ADA Curb Ramp New Construction Inspection Form (Perpendicular)

Nw 291 ave

23885.56

Nw fair st

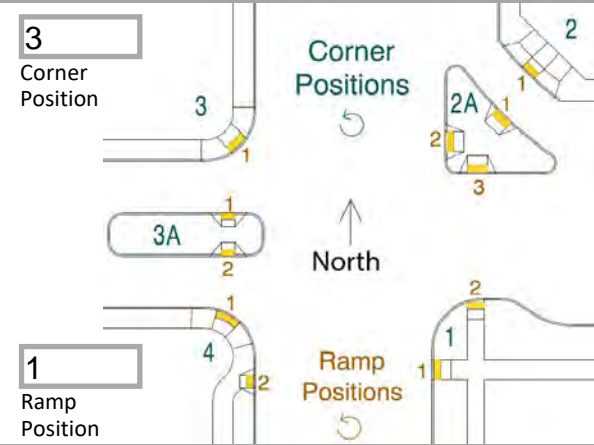
Turn space less than 4 ft clear width
